23-98 OLNEY HOUSE - New construction
2003 23/98-2-00A

OLNEY HOUSE SPRINGHOUSE
ROUTE 108, OLNEY, MARYLAND

1. View from Southwest. Note severe lean of stone wall on right side of building.

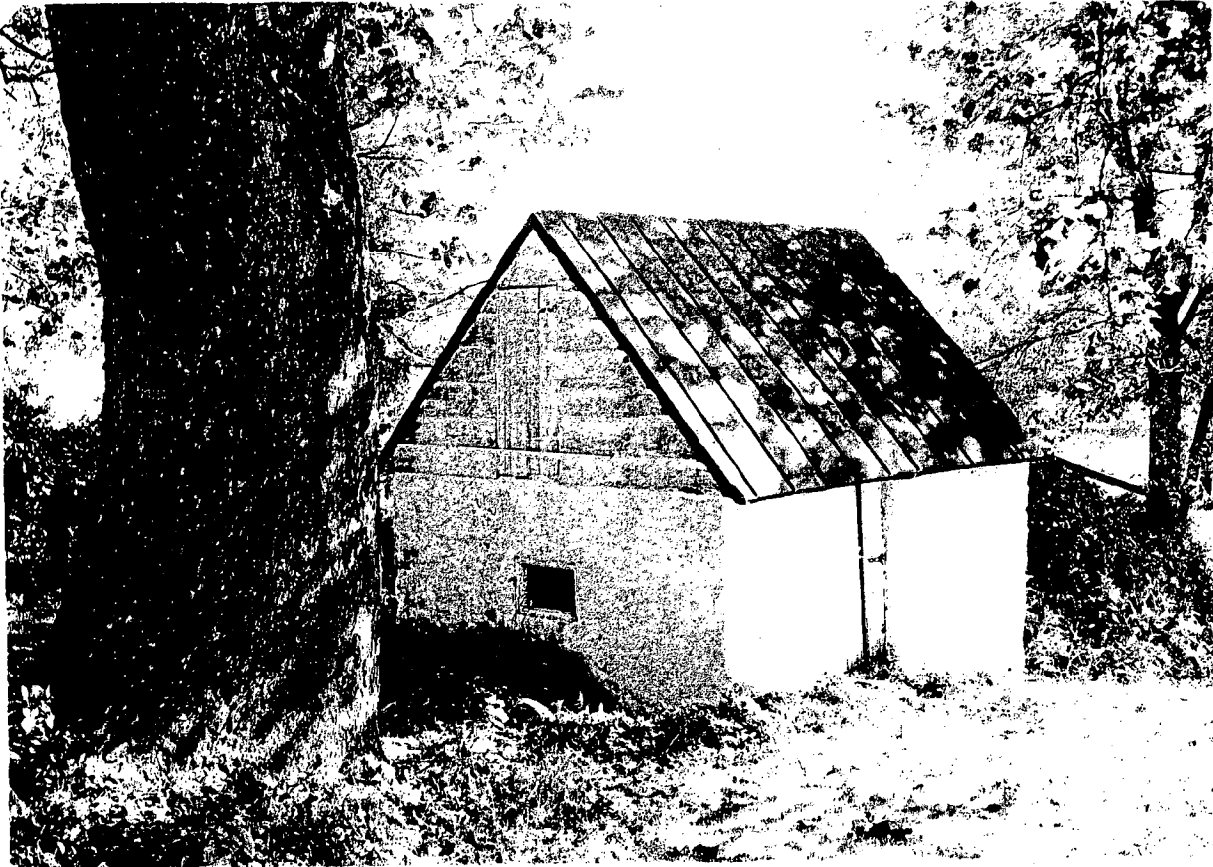
2. Three inch wide crack in east wall due to outward and southward movement.
